CDM: Recommendation Form for Small Scale Methodologies (version 01)
(To be used for presenting questions/proposals/amendments to the simplified methodologies for small-scale CDM project activity categories)

<i>Date of SSC WG meeting:</i>	21–24 June 2011, SSC WG 32
<i>Title/Subject (give a small title or specify the subject of your submission, maximum 200 characters):</i>	Clarification on the applicability of AMS-II.H for a new Power and Cooling system in an Industrial facility
<i>Indicative methodology to which your submission relates (refer the items of Appendix B of the Simplified Modalities and Procedures), if applicable.</i>	AMS-II.H “Energy efficiency measures through centralization of utility provisions of an industrial facility”
<i>Name of the authors of the query:</i>	Thomas Watson Institution: Thomson Electric company thmswtsn8@gmail.com

4. A Flow diagram indicating both the Baseline and Project scenario:

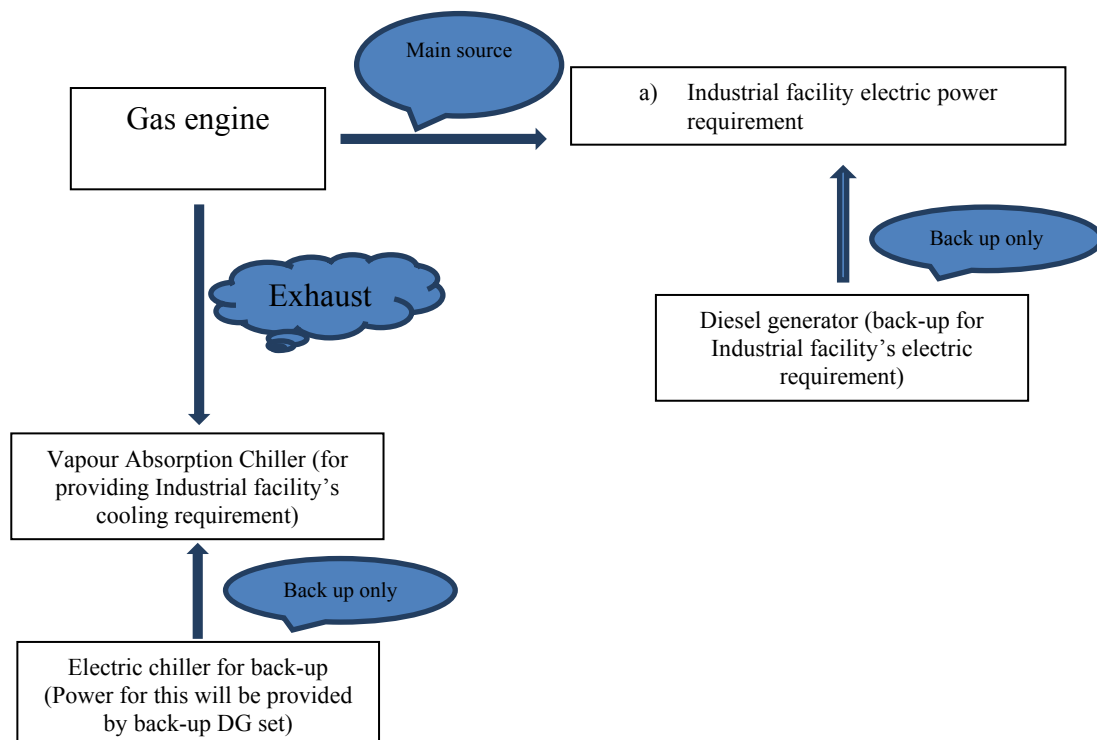
I have a specific question regarding the suitability of a project to methodology AMS II H version 3, I intent to develop an (industrial facility) small scale project – with gas engine for power generation and its exhaust (direct) utilized in VAM for chilled water generation. As for my understanding the project is co-generation as simultaneously power and cooling is produced. But the methodology AMS II H version 3 (applicable for industry facility) applies to Combined Heat and Power (CHP) and Combined Cooling, Heating and Power (CCHP) system. This project though cogeneration does not fit under CHP or CCHP category as it involves Cooling and Power only (CP), hence i seek your guidance whether this project qualifies for this methodology or not.

As per the meth II H version 3, emissions due to operation of stand-by equipment should be accounted as project emissions. In a specific situation wherein (Grid + DG set) is the baseline and the project case is (Gas engine + DG set), in both the situations DG is backup. In this context is it appropriate to consider the operation of DG set (project activity backup) in the project emissions since it's the same case as that of the baseline?

In response to the first question, the SSC WG understands that the underlying project involves a gas engine for power generation and its exhaust heat (direct) is utilized in vacuum absorption chiller for chilled water generation. The group is of the opinion that the project can be considered a cogeneration unit since it involves a simultaneous production of electricity and heat (cooling as heat energy). The project activity may therefore be eligible under AMS-II.H provided that all other elements of the methodology are also satisfied.

In response to the second question, the SSC WG agreed to clarify that project emissions due to the operation of back-up or stand-by systems (chillers, boilers, generators, etc.) emissions in the project shall be taken into account per the requirements of AMS-II.H (for example, per paragraph 21). This is because without data collection during the crediting period the relative emissions of project and baseline back-up (or stand-by) systems cannot be determined. In the particular case of the described project, the relative operation of back-up units in the baseline and project case depends upon differences in reliability between the baseline system utilizing grid electricity and electric chillers and the project system utilizing cogeneration systems and VAM chillers.

The SSC WG also notes that “captive plants” as referenced in AMS-II.H, includes back-up and stand-by generation systems.
